Gachsaran Polymer Industries Company PIDMCO	Gachsaran Polymer Industries Company HDPE Plant		
	General Arrangement Drawing (2D) (Tie-In Points , Skid Dimensions & Orientation, Including Instrument, Junction Box and Local Panel Location Layout & Instrument Cable routing.) for Refrigerator Package	 	
PO No.: GPIC-PT-MA-PO-000-3029	Document Number: VD-GPIC-MA-3029-3029-0062	Rev. 04	Page 1 of 12

General Arrangement Drawing (2D) (Tie-In Points , Skid Dimensions & Orientation, Including Instrument, Junction Box and Local Panel Location Layout & Instrument Cable routing.) for Refrigerator Package

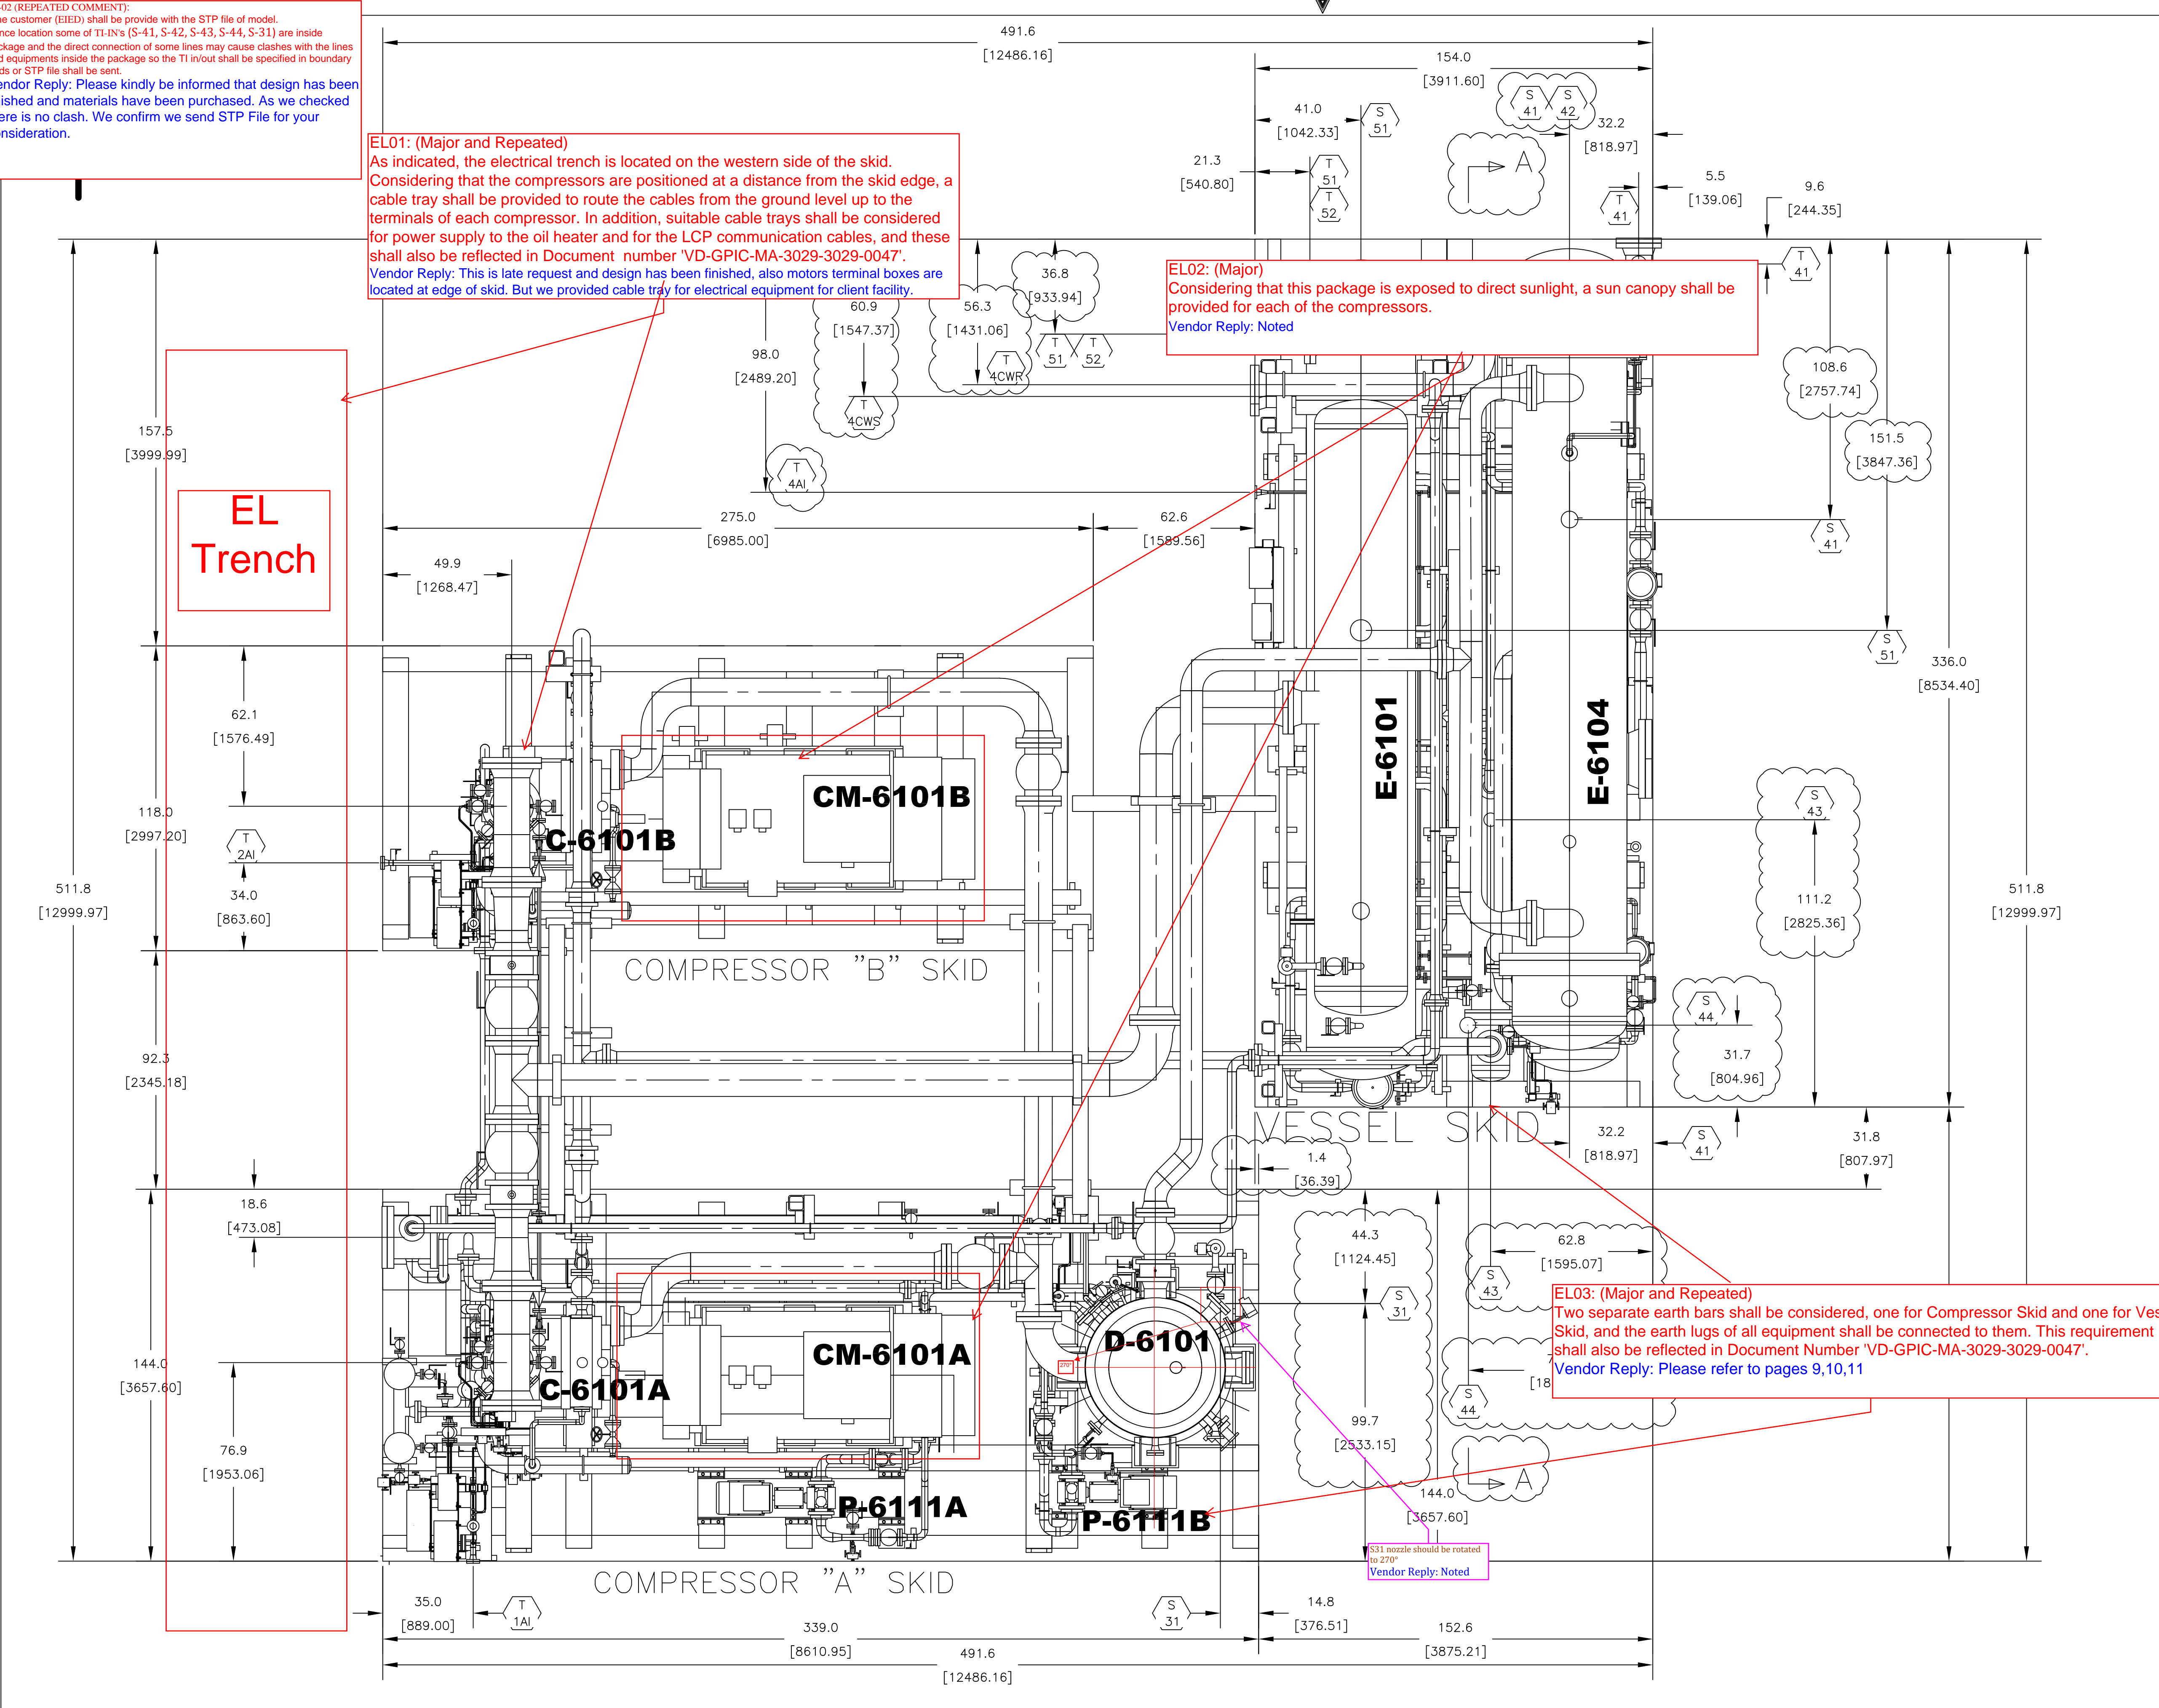
PI-02 (REPEATED COMMENT):
 -The customer (EIED) shall provide with the STP file of model.
 -Since location some of TI-IN's (S-41, S-42, S-43, S-44, S-31) are inside package and the direct connection of some lines may cause clashes with the lines and equipments inside the package so the TI in/out shall be specified in boundary skids or STP file shall be sent.
 Vendor Reply: Please kindly be informed that design has been finished and materials have been purchased. As we checked there is no clash. We confirm we send STP File for your consideration.

EL01: (Major and Repeated)
 As indicated, the electrical trench is located on the western side of the skid. Considering that the compressors are positioned at a distance from the skid edge, a cable tray shall be provided to route the cables from the ground level up to the terminals of each compressor. In addition, suitable cable trays shall be considered for power supply to the oil heater and for the LCP communication cables, and these shall also be reflected in Document number 'VD-GPIC-MA-3029-3029-0047'.
 Vendor Reply: This is late request and design has been finished, also motors terminal boxes are located at edge of skid. But we provided cable tray for electrical equipment for client facility.

EL02: (Major)
 Considering that this package is exposed to direct sunlight, a sun canopy shall be provided for each of the compressors.
 Vendor Reply: Noted

EL03: (Major and Repeated)
 Two separate earth bars shall be considered, one for Compressor Skid and one for Vessel Skid, and the earth lugs of all equipment shall be connected to them. This requirement shall also be reflected in Document Number 'VD-GPIC-MA-3029-3029-0047'.
 Vendor Reply: Please refer to pages 9,10,11

S31 nozzle should be rotated to 270°
 Vendor Reply: Noted

FRONT VIEW

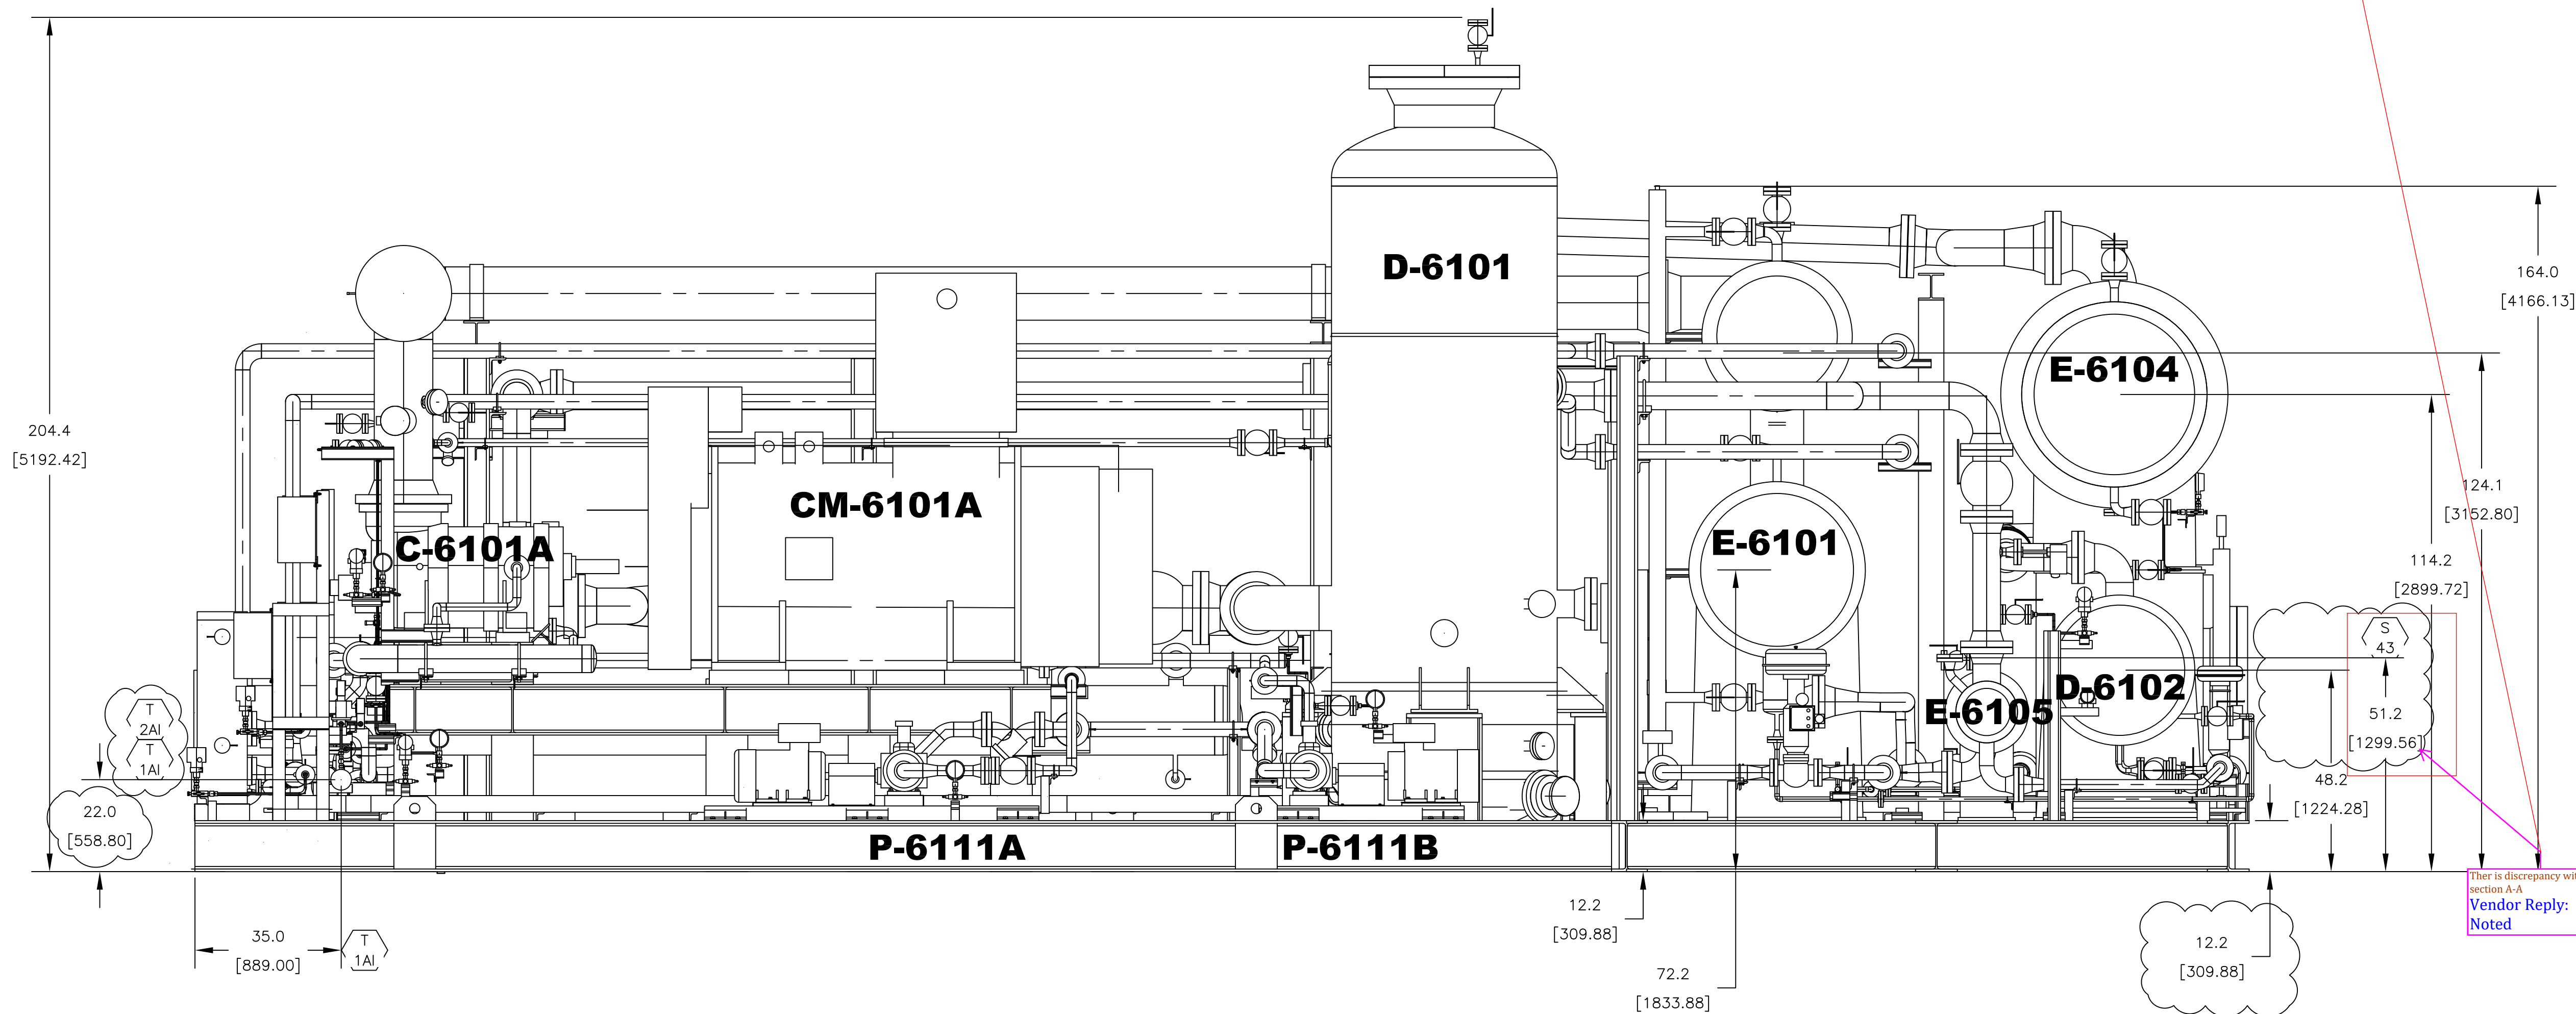
There is discrepancy with section A-A
Vendor Reply: Noted

DRAWING NO.	REV.	SHEET NO.	SIZE
VD-GPIC-MA-3029-3029-0062	04	8 of 12	A1

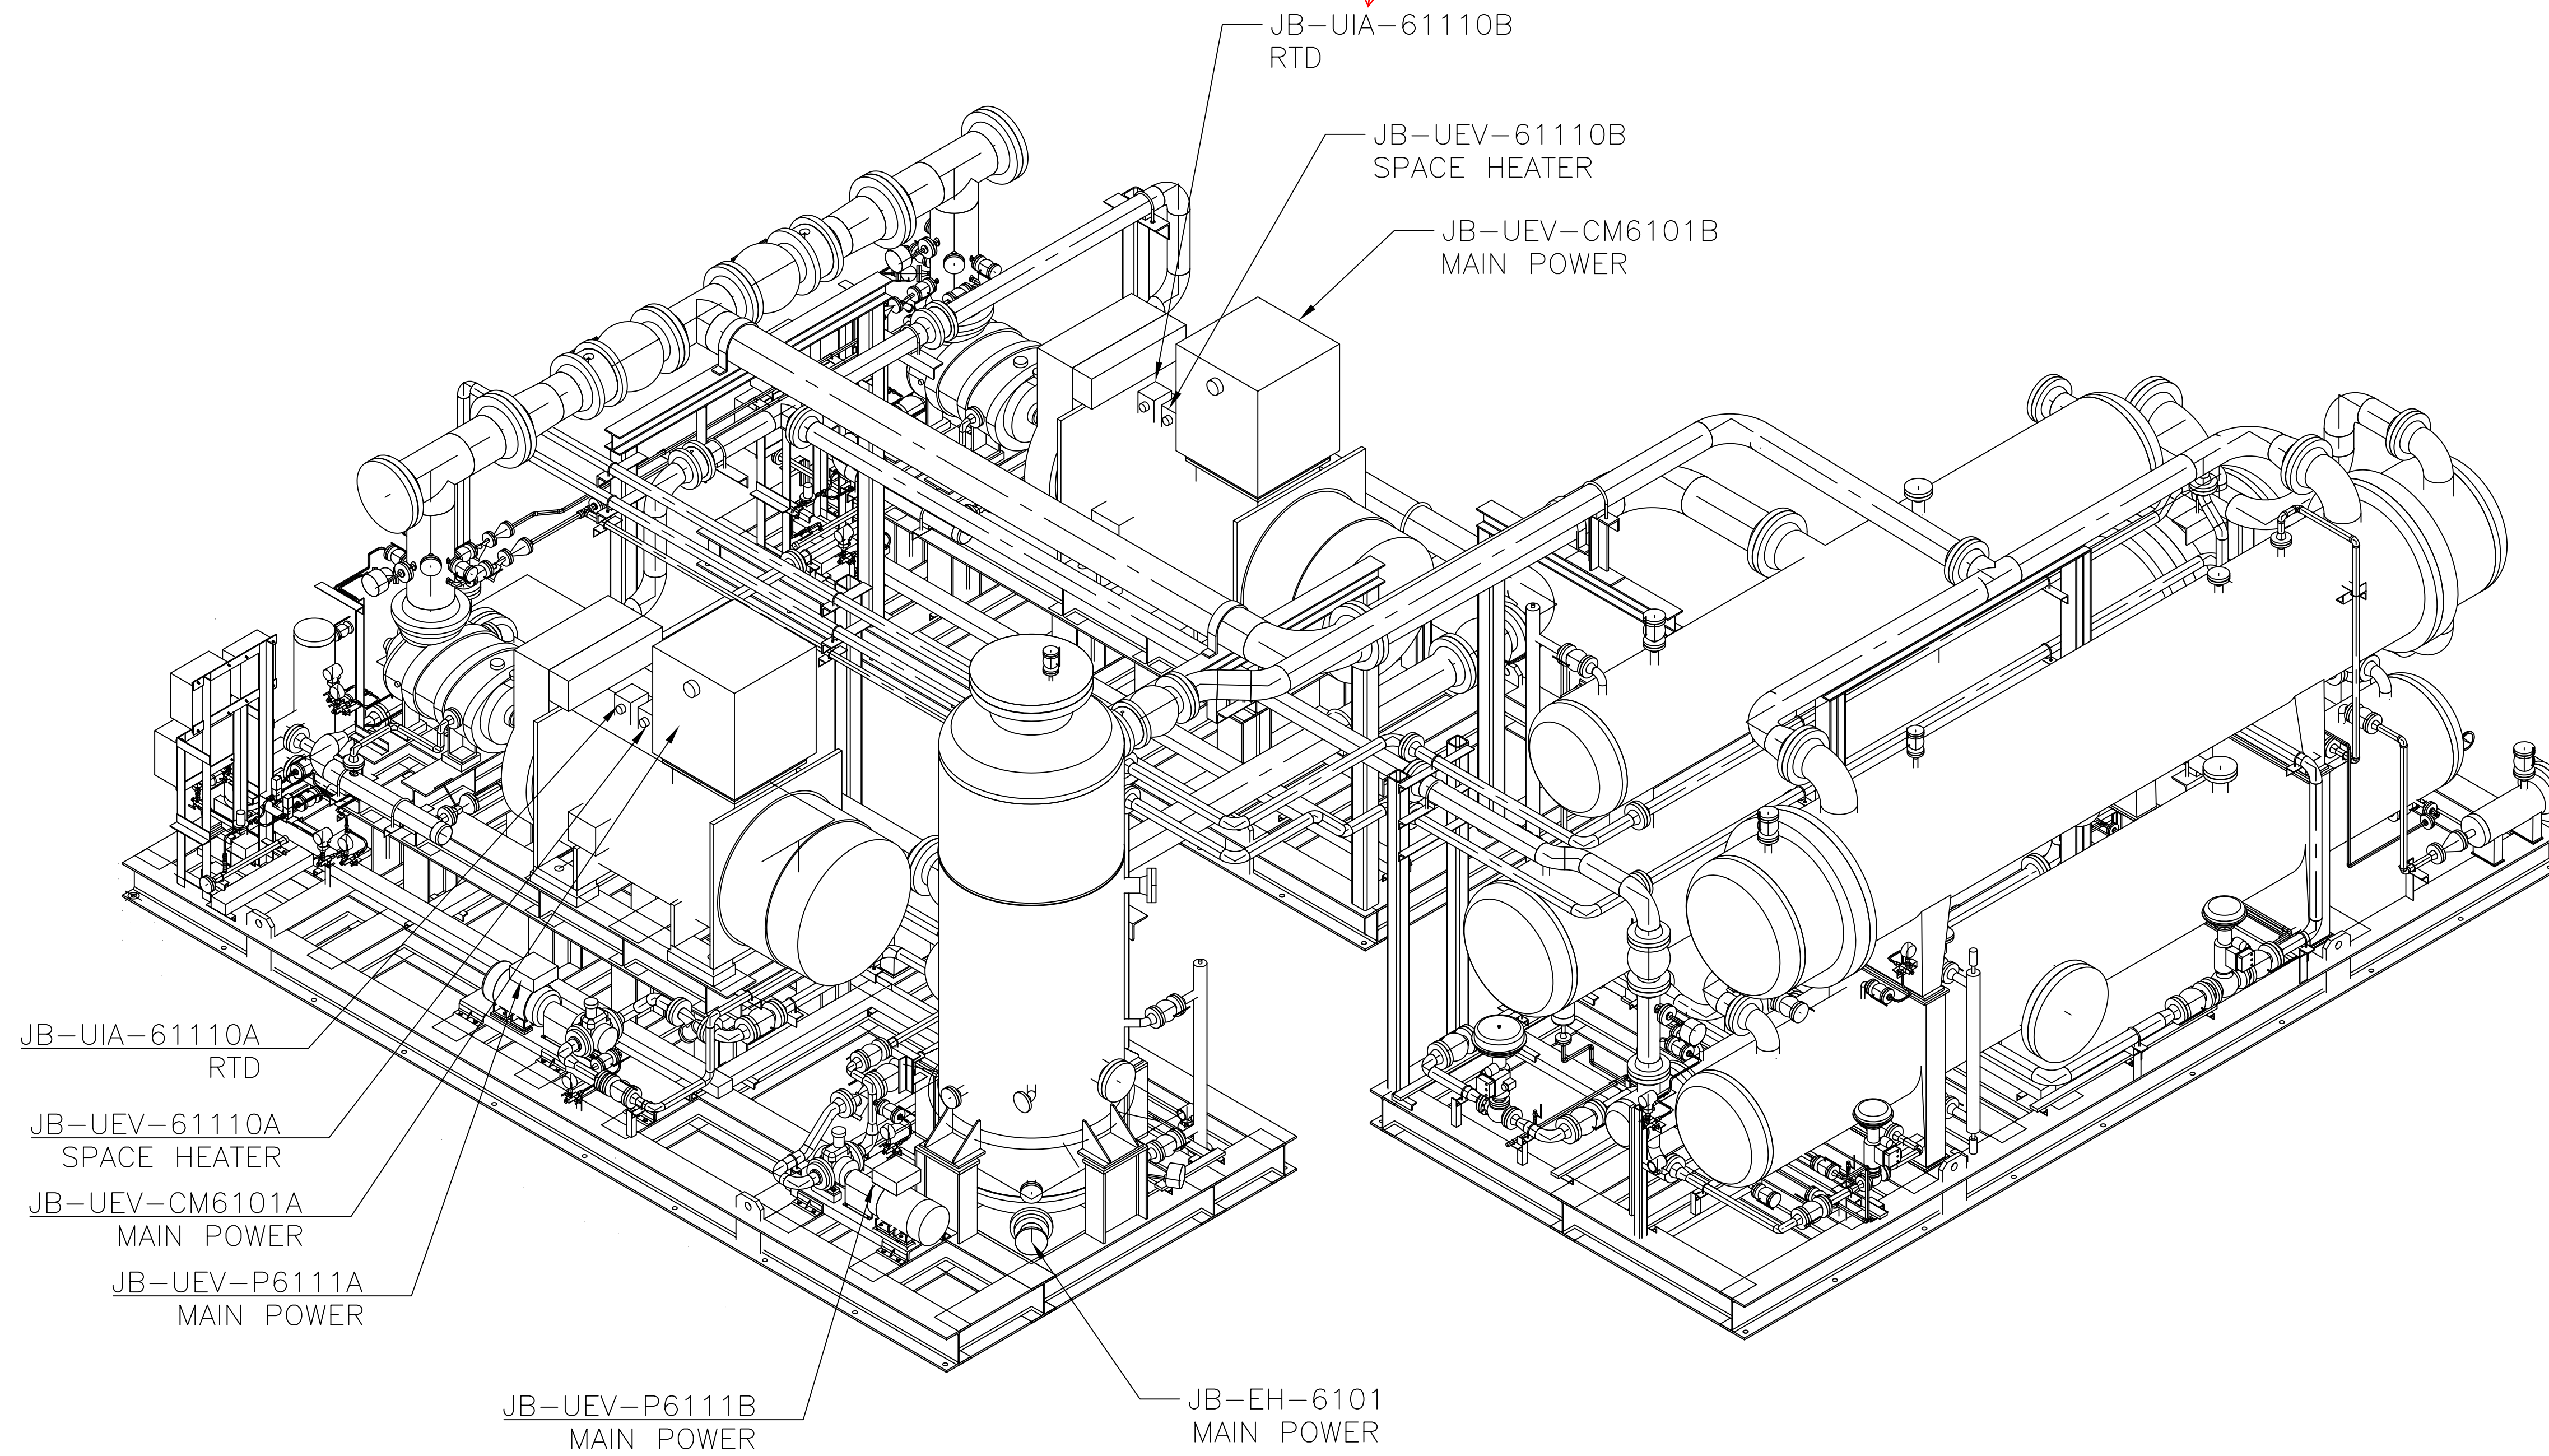
IN-02 Tag number of all JB and LCP shall be corrected based on final revision of IO list.
Vendor Reply: Noted

IN-01. In addition to GA, this document is cable route and for cable route, symbol for instrument cable tray/ladder/conduit/JB shall be specified clearly in symbol and legend and related cable route shall be shown in the drawing. Width/depth/size of trays/ladders/conduits shall be added and shown in this drawing.
Vendor Reply: Please kindly note that we have shown cable routing, JB, LCP in this GA. Also we have submitted 3D model for exact sizing and dimension. These are inside the package and we have followed project requirements. In previous projects we did not show cable routing in GA but as per your comment, we have shown in this project.
